CABINET MEMBER FOR ENVIRONMENT – 25 MAY 2017

PROPOSED WAITING RESTRICTIONS AND TRAFFIC CALMING BANKSIDE, BANBURY

Report by Director for Infrastructure Delivery

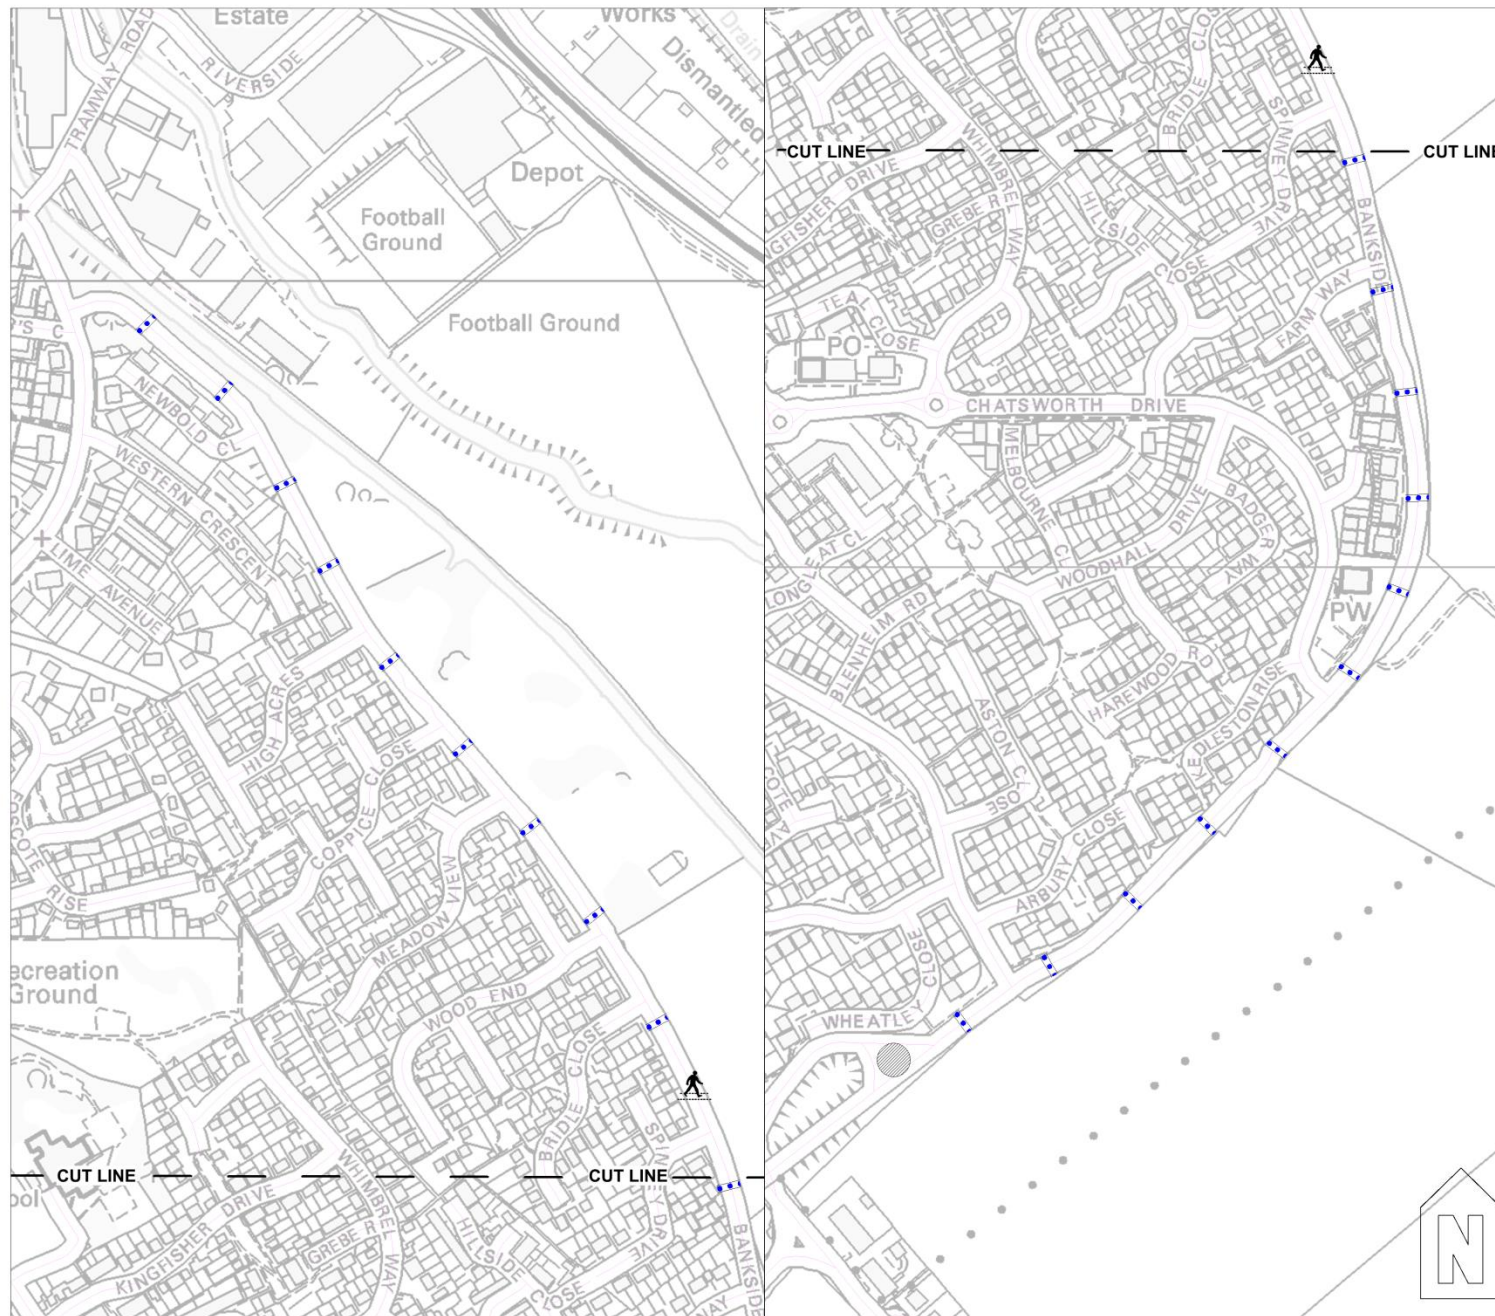
23. The proposed replacement of the existing traffic calming chicanes by a system of speed cushions was also overall supported by a majority of the respondents.
24. Some of the respondents' objections to the proposed use of speed cushions stated they significantly preferred the current traffic calming chicanes, and were also concerned about the potential damage to vehicles caused by passing over a large speed cushion, and also potential noise issues as vehicles pass over the cushions.
25. Some responses - while not objecting to the principle of the use of speed cushions - nevertheless queried the number being proposed and requested consideration of a reduced number of features.
26. Stagecoach Oxford, who operate bus services here, expressed no objection with the proviso that the specification of the cushions is 'bus friendly'.

27. The spacing of the speed cushions (approximately 80 metres apart) is in accordance with normal practice and design guidance based on research published by the Department for Transport. 'Bus friendly' speed cushions are proposed and in practice – from observations of schemes using a similar specification and spacing of cushions – cars are able to progress over these

at 30mph with minimal if any requirement to slow at each feature, yet are effective in reducing the amount of traffic travelling in excess of the speed limit, and have not been found to result in noise issues or any concerns over damage to vehicles.

28. Monitoring of the performance of the existing traffic calming chicanes shows that while they undoubtedly reduce speeds in the vicinity in particular for the traffic required to give way, away from the chicanes speeds can be quite high. Additionally, although not a severe problem, from time to time injury accidents are reported at the chicanes

29. One objection was received from a resident adjacent to the site concerned about its impact on the property, including light pollution from the beacons, and also concerned that the proposed location was not in the best location to serve existing pedestrian crossing demands. A further two objections were received on the grounds of the crossing not serving existing pedestrian crossing demands (there were also some other comments not framed as objections also making this point).

30. It is accepted at present there may be fairly limited pedestrian crossing demand at the site of the proposed crossing, however it is close to the proposed new junction from the Longford Park development, and will therefore be well placed to serve the pedestrian crossing demand generated by the development.
31. The objection from the residents directly adjacent to the crossing is noted. Such concerns are understandable but there appears to be little scope to amend the location of the crossing to an alternative location that would still provide a convenient crossing point for pedestrians travelling to / from the development, which is funding the crossing, and it should be also noted that the development itself will significantly change the appearance of the land on the east side of Bankside. Light pollution from the zebra crossing beacons can

be addressed by installing hoods so that there is minimal light spillage to adjacent properties.

BANKSIDE, BANBURY
 PROPOSED
 PARKING RESTRICTIONS

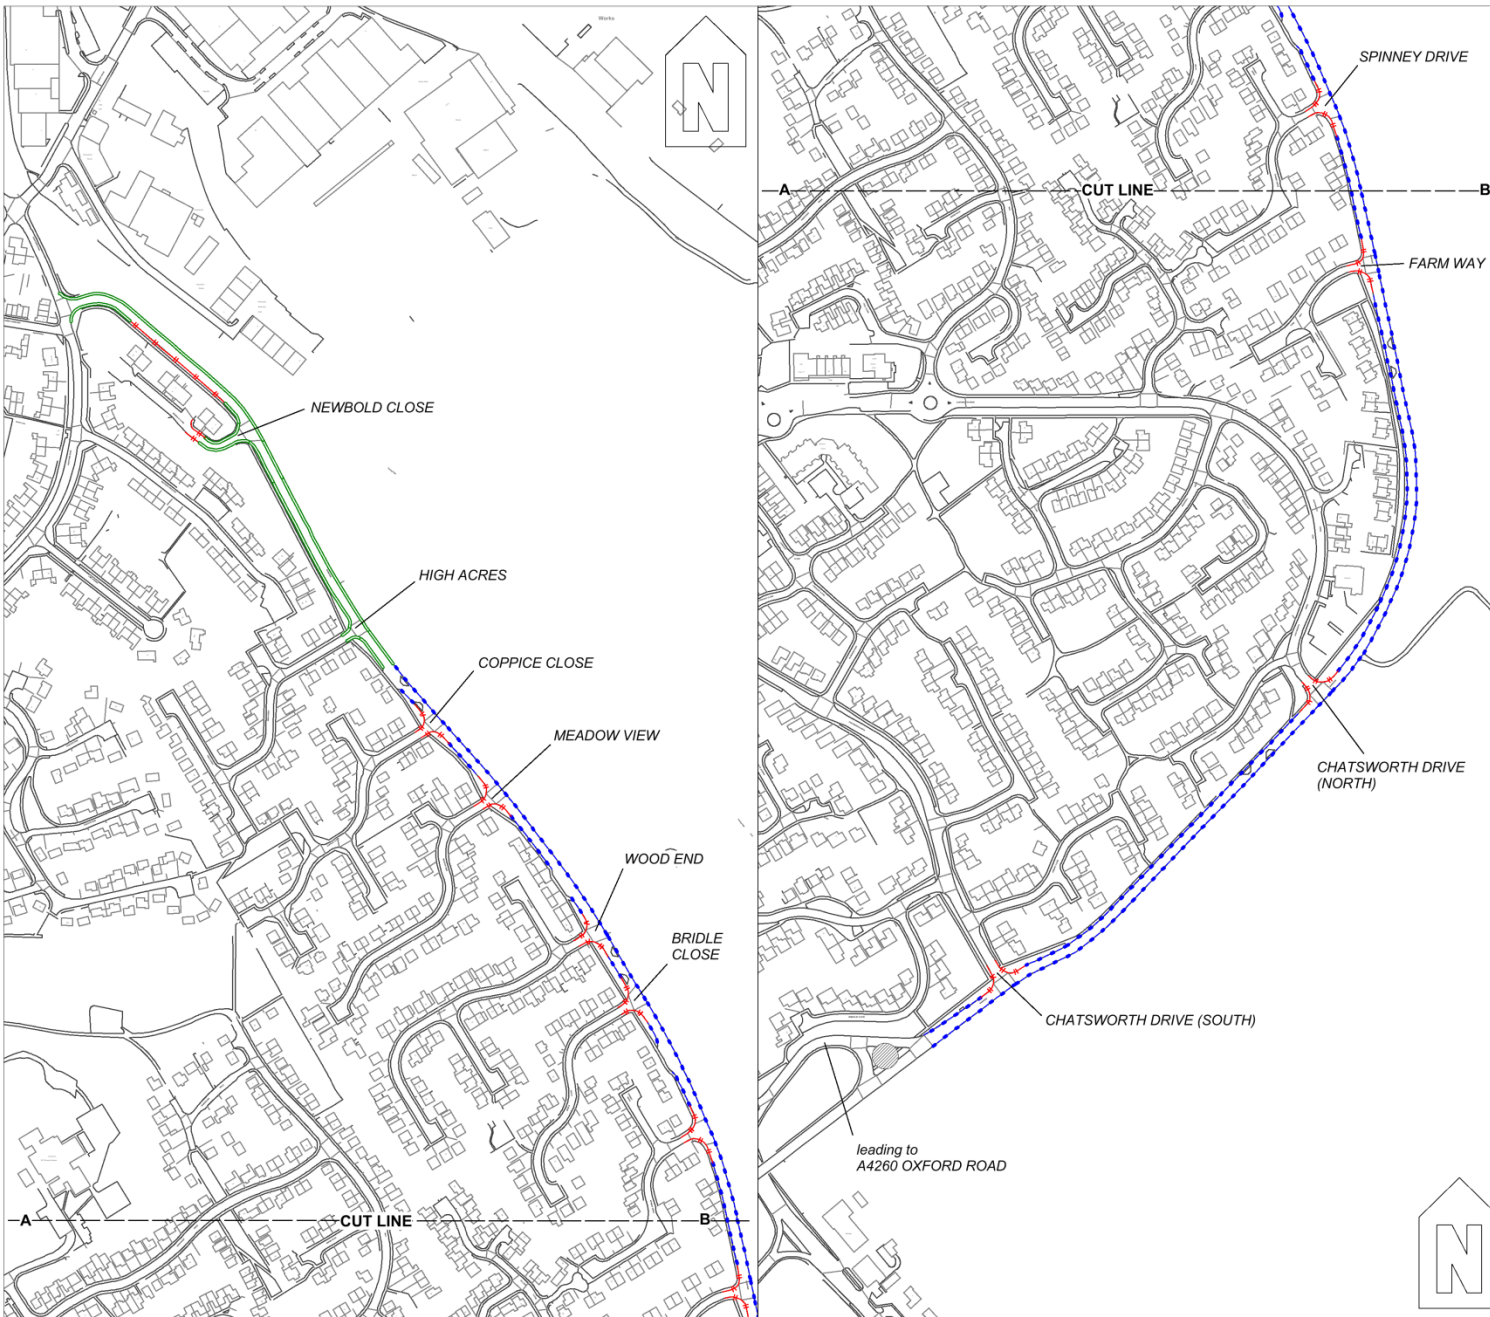
11. These objections primarily related to the proposed ‘no waiting between 8am and 6pm Mondays to Saturdays’ on the grounds that there is no convenient alternative parking provision nearby for residents of Bankside, noting that while many of the properties on Bankside did have garages accessed from the rear of the property, these were small and not in practice usable by many vehicles, and that on-street parking provision on the adjacent side roads was already under pressure, and that parking displaced from Bankside would cause difficulties for residents of these roads in addition to the inconvenience for Bankside residents.

12. Some respondents suggested the provision of more parking laybys on Bankside, to be funded by the developers, with the suggestion made by some respondents that the use of these laybys should be restricted to residents.

13. It was also suggested by some respondents that the impact for residents could be reduced by limiting the time period the waiting restrictions applied.

14. The proposals for 'no waiting at any time' on the length of Bankside between its junction of Hightown Road and Newbold Close however appeared to be broadly supported – the current parking along the latter part of Bankside is primarily used for commuter parking rather than by residents, and can result in an appreciable restriction for traffic at times.
15. A small number of concerns were raised over the proposed 'no waiting at any time' restrictions on Bankside at its side road junctions on the grounds that it would lead to further parking pressure on the side roads.

16. The objections relating to the proposed 8am to 6pm Monday to Saturday restrictions are noted and it is accepted that in practice some residents may have significant difficulty in finding suitable alternative parking spaces, and that parking displaced to the side roads would further add to parking pressures experienced in some of these locations.

17. The request for the introduction of a residents parking scheme in the area is noted, but while not ruling out consideration of this in the future, it is not considered possible at present, in particular bearing in mind that civil parking enforcement is not currently in place within the Cherwell District Council area.

18. The provision of further parking laybys at the locations where there is on-street waiting adjacent to housing would require further investigation to assess feasibility and costs; currently there is no identified funding that could be used to fund such works.

19. Balancing the inconvenience to residents impacted by the removal of parking against the benefits that could be achieved from the proposed restrictions for traffic using Bankside is challenging. In addition to allowing buses to operate easily with the proposed traffic calming, the proposed restrictions would assist cyclists using the proposed cycle lanes.

20. Taking all these factors into account it is suggested that the majority of the advertised restrictions on Bankside should be approved for implementation. However, in those key locations where the proposed 8am to 6pm Monday to Saturday limit would cause particular difficulty for residents then no restriction should be introduced at this stage. Officers will carry out local consultation with residents and the local Councillor to determine the extent of these gaps in the restriction, but these are expected to focus on the sections of Bankside between Meadow View and Wood End, and also to the north of the Chatsworth Drive (north) junction.
